COPPERSTRING EIS

Attachment F - Vegetation Clearing Works plans

Dajarra Road to Mount Isa

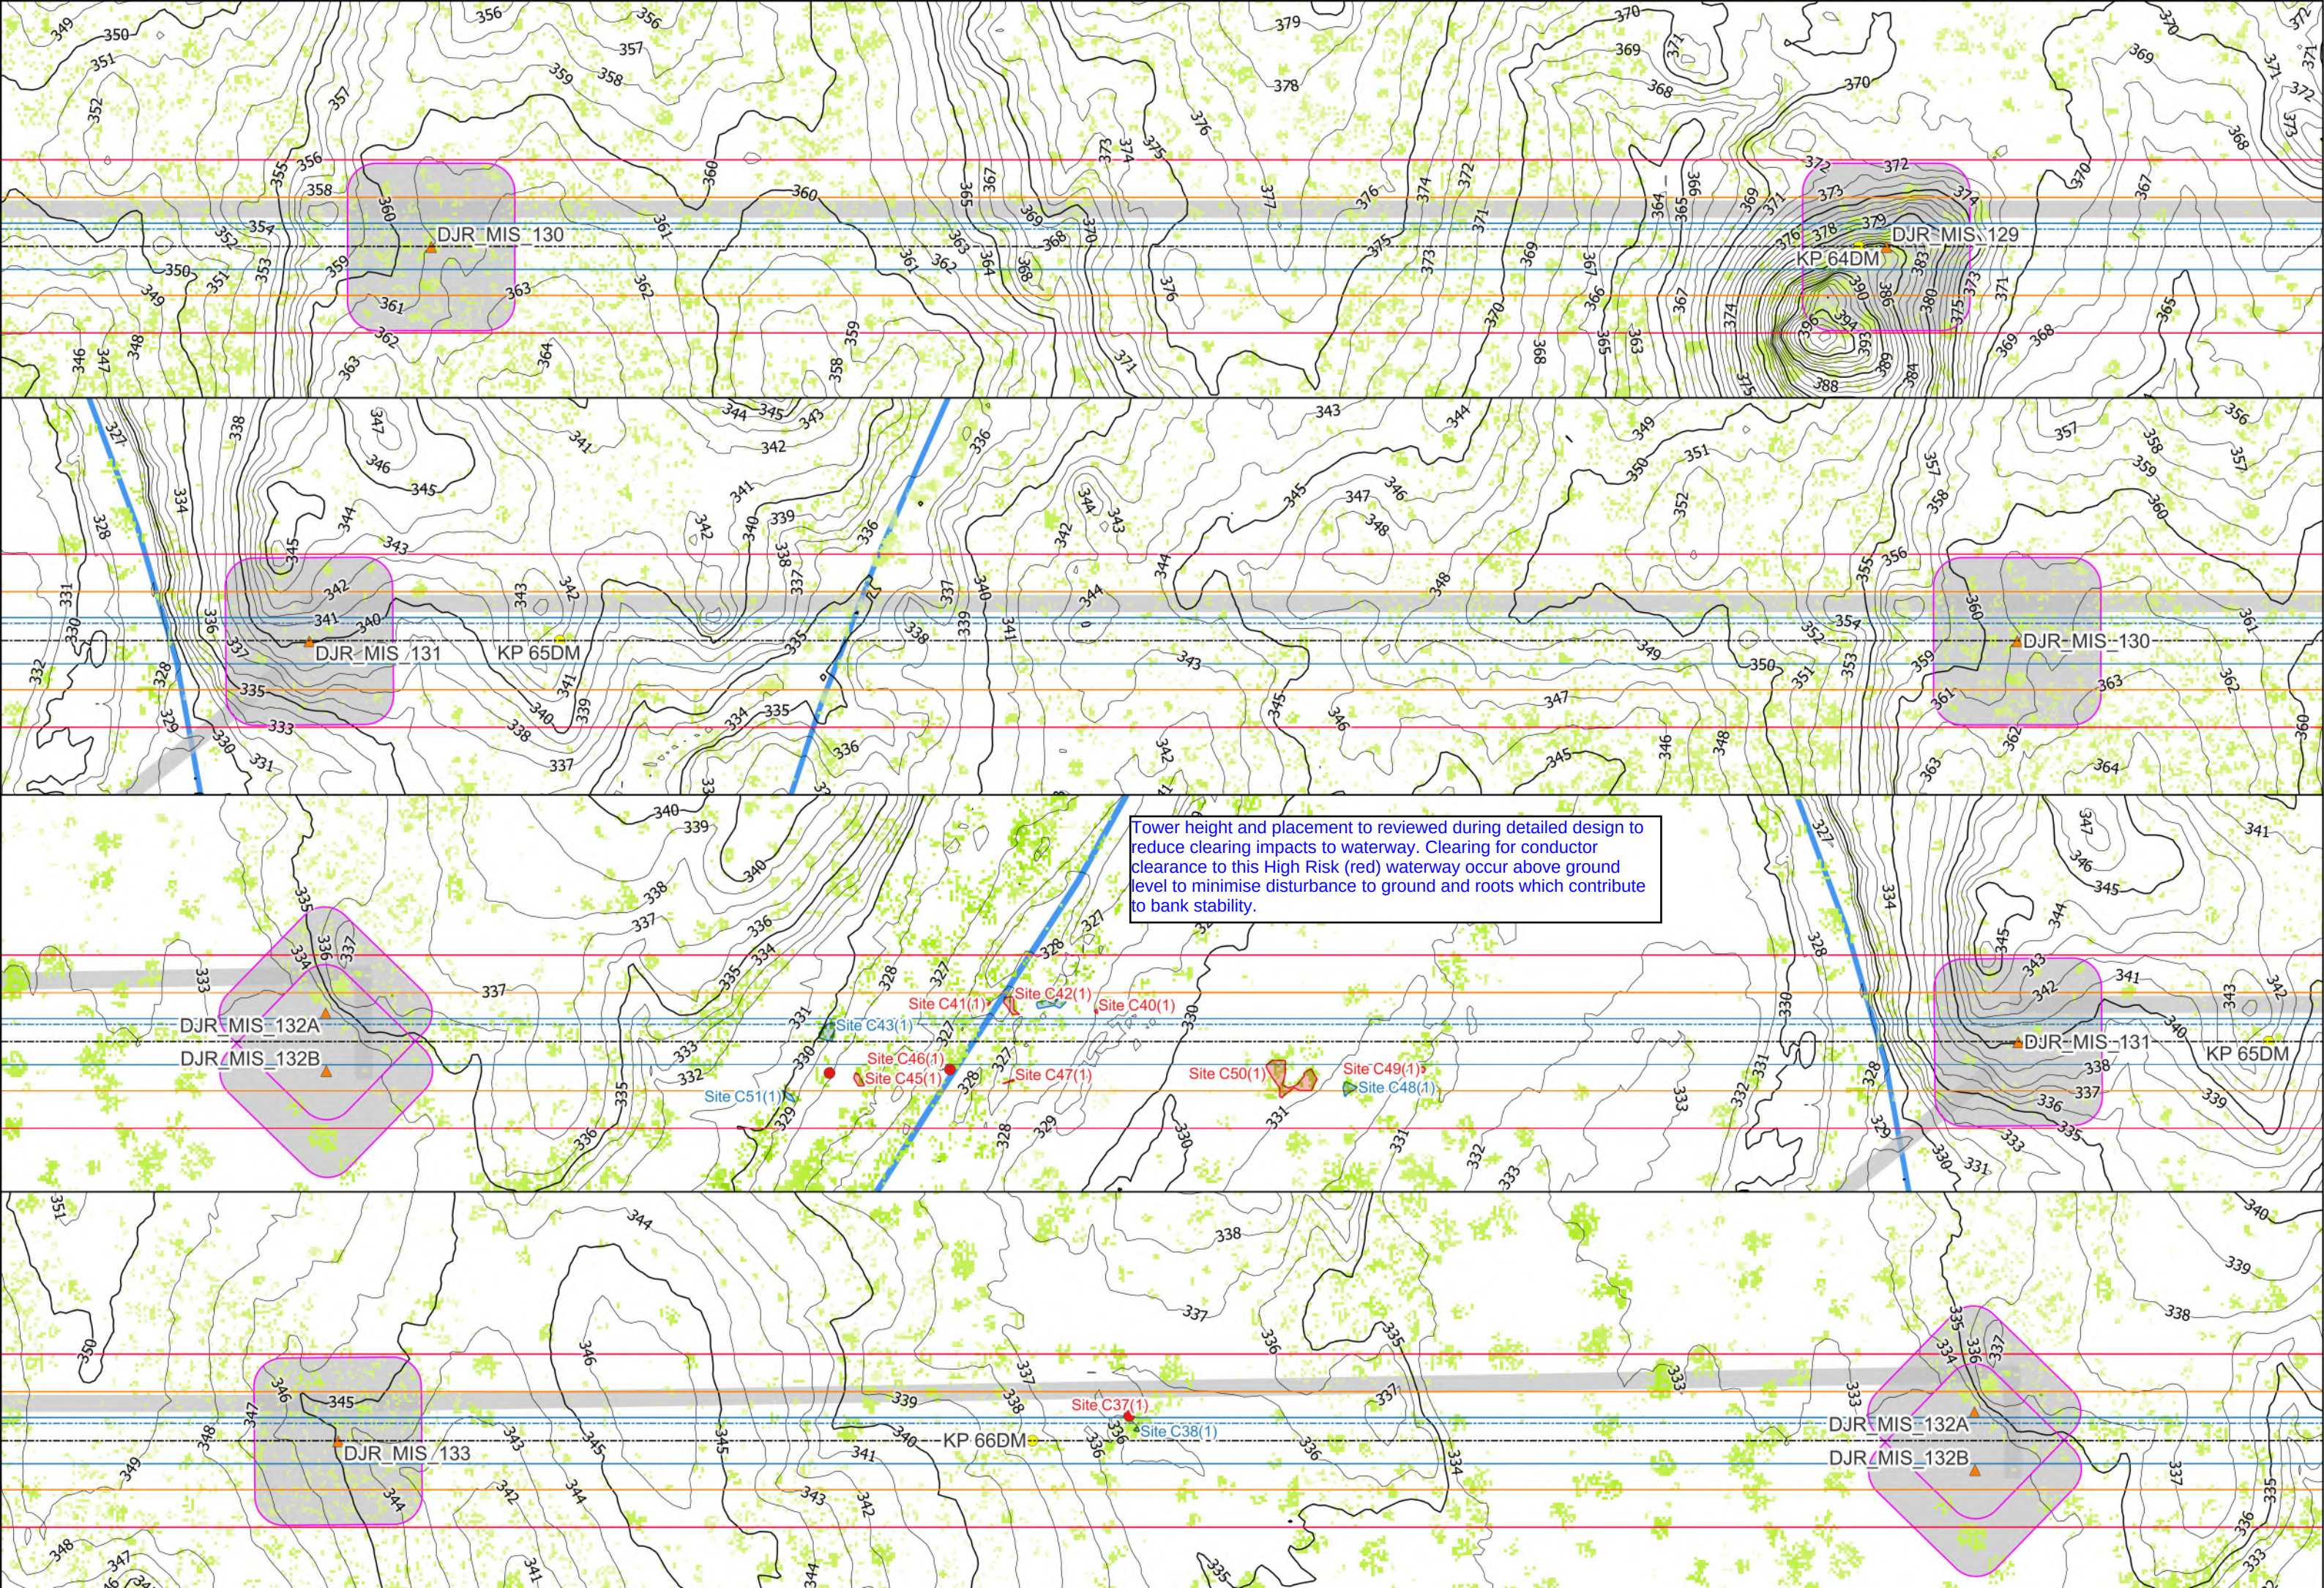
Tower assembly area to be reconfigured to not be within 15m of the high bank of waterway and to avoid clearing near or within the bed and banks for the waterway

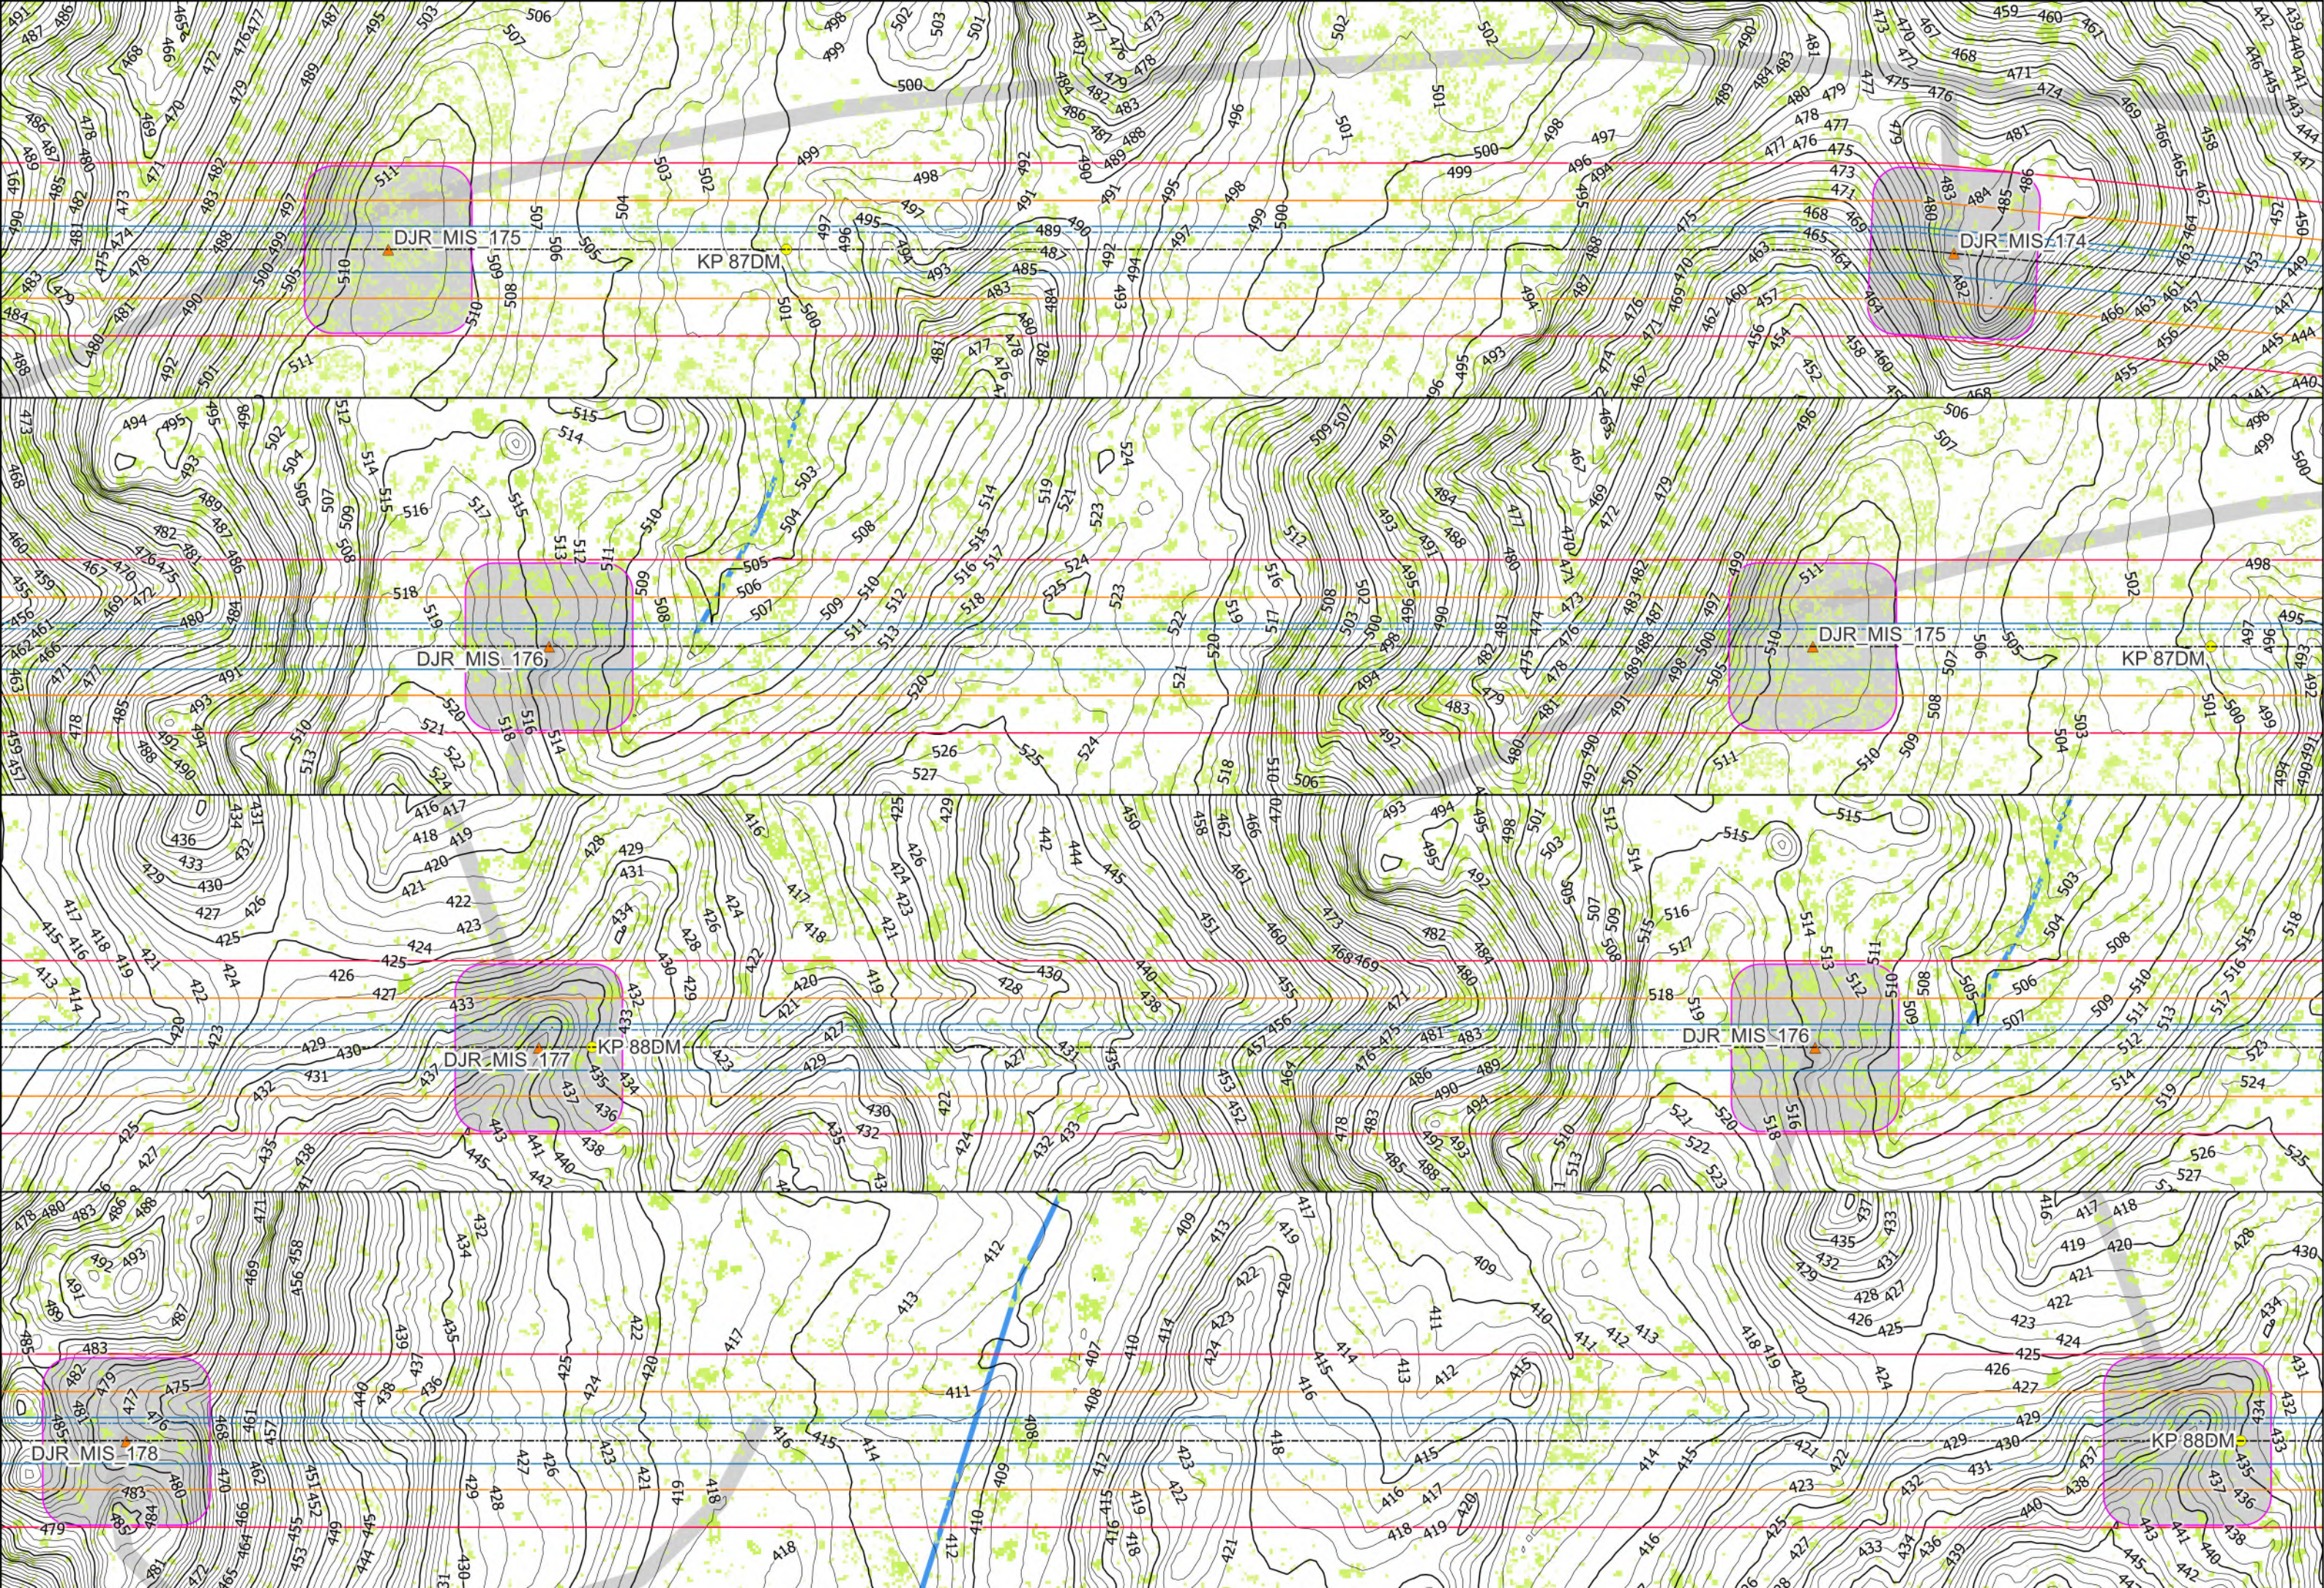
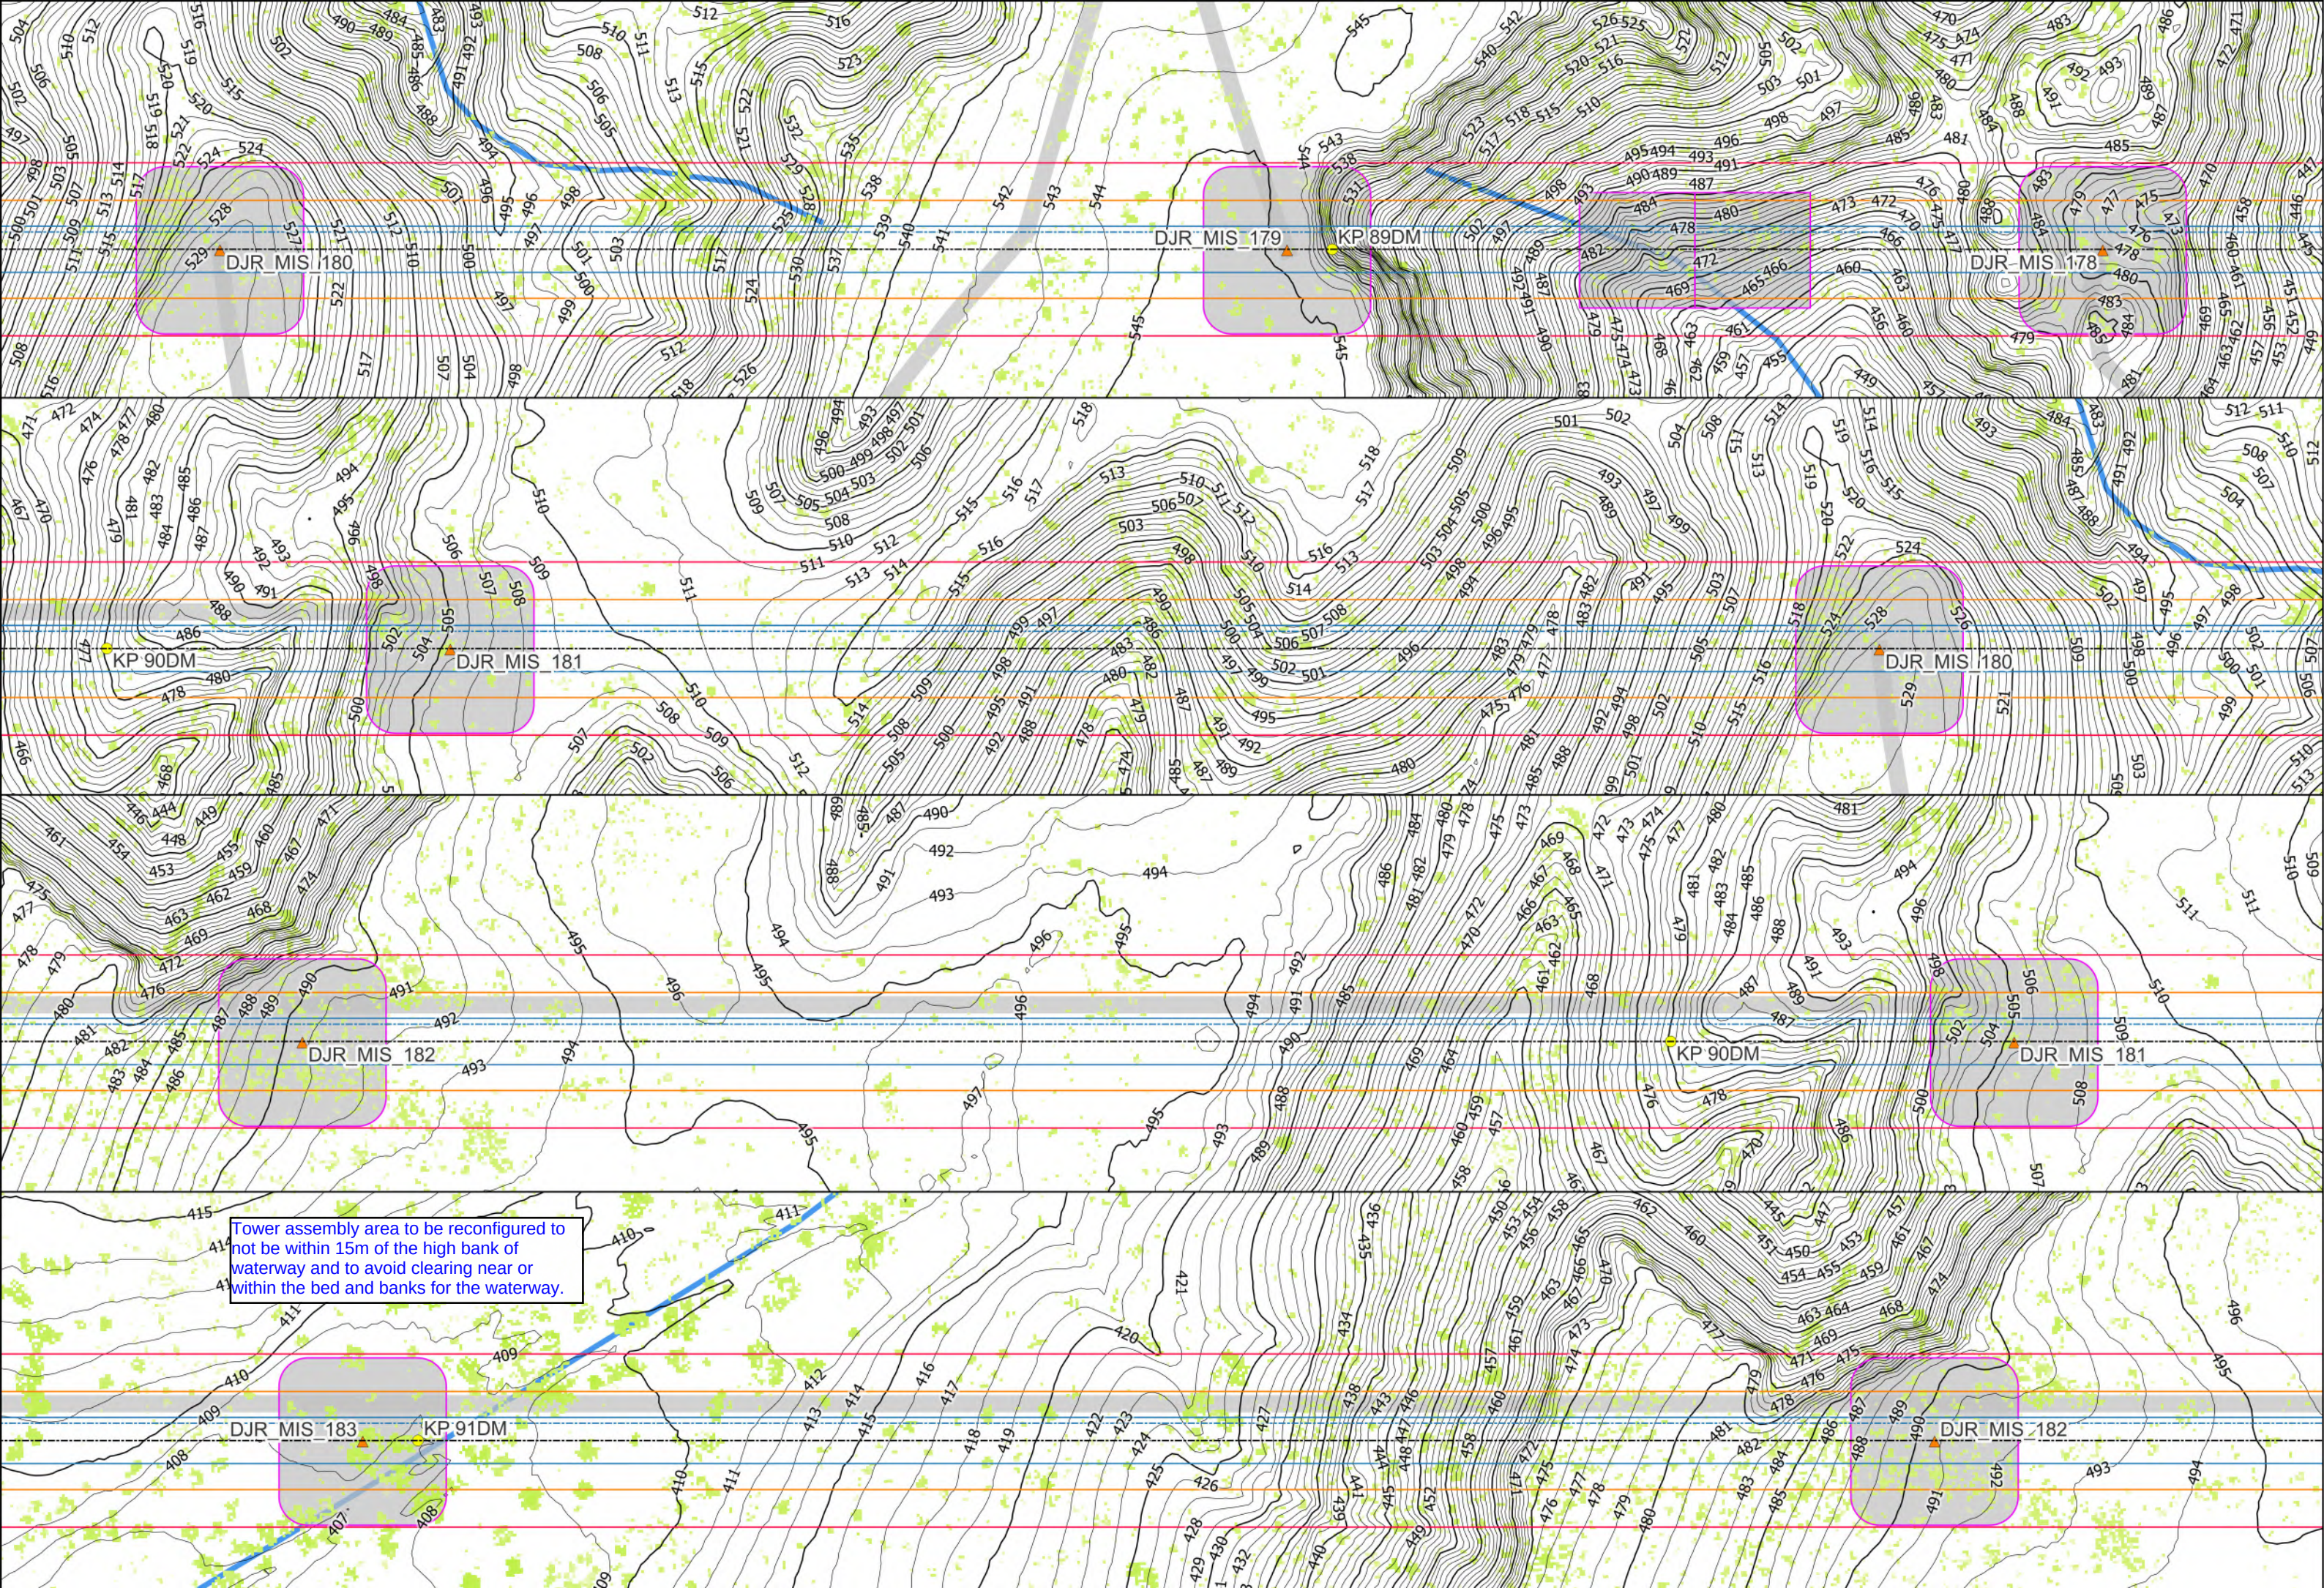
Tower assembly area to be reconfigured to not be within 15m of the high bank of waterway and to avoid clearing near or within the bed and banks for the waterway.
